Southern Silver Exploration Corp. (U.S.)

Responses to Comments to NMMD Permit Application No. LU048EM – Hermanas Project

Following are responses to Agency Review Comments and requests for additional information regarding the Hermanas Project NMMD Minimal Impact Permit Application electronically received from the New Mexico Energy, Minerals and Natural Resources Department dated July 14, 2023.

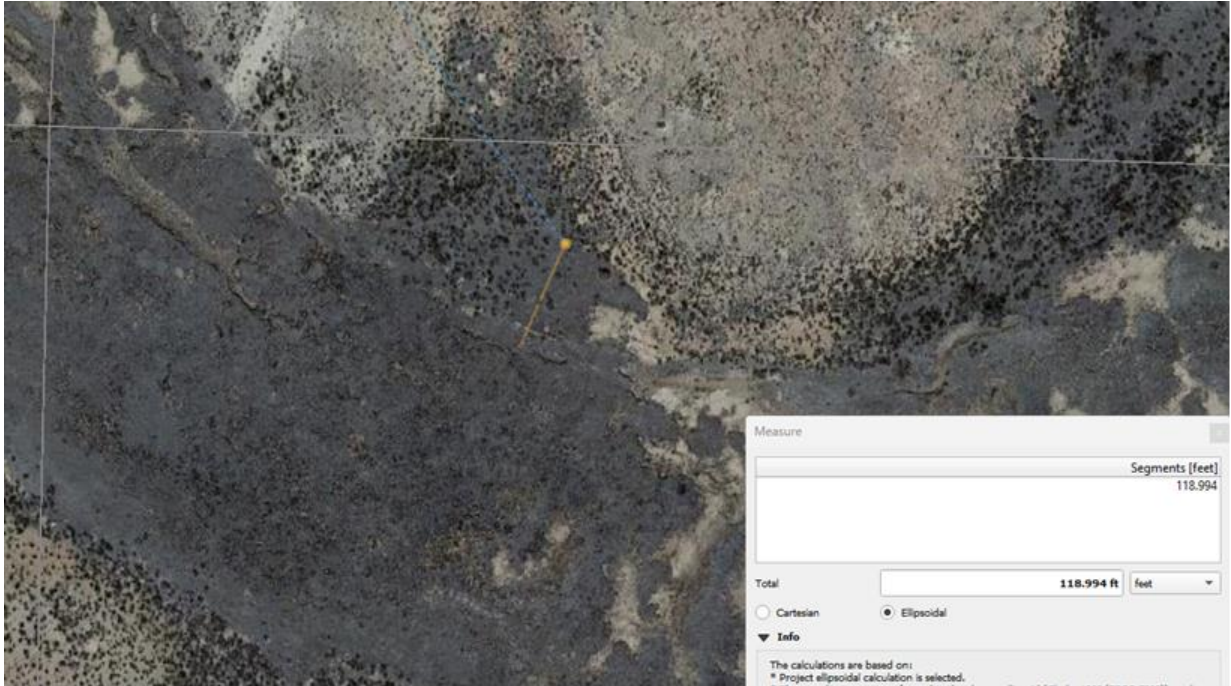
NMED Mining Environment Compliance Section, Ground Water Quality Bureau Comments:

Three wells were identified in an internet search for the area; however, no TDS data was found to determine values in ground water. See Professor Phillips' comment in the email above that his testing many years ago showed the water on the Johnson Ranch had "high TDS" compared to drinking water but was not saline. Because no ground water encountered during exploration drilling will be released from the mud sumps, there shouldn't be a need for ground water sampling of the water from drilling. Any ground water that might seep through the walls and pit of the unlined sumps will not have any toxic fluids introduced because no toxic fluids are used during drilling. Any anomalously high concentrations of metals naturally occurring in the ground water should be removed effectively by adsorption onto abundant clays and iron/manganese oxides in the desert soil. MSDS fact sheets for all fluids utilized on site will be available on the drill rig.

To avoid excess water overflowing the sumps, a trash pump and hose will be available to distribute water to a nearby drill site or a second mud sump can be constructed within the permitted drill pad. There will be significant room on the pads to construct an additional mud sump if necessary.

Sumps as described in the permit will hold approximately 5,700 gallons when full after evaporation and leakage into the pit floor and walls.
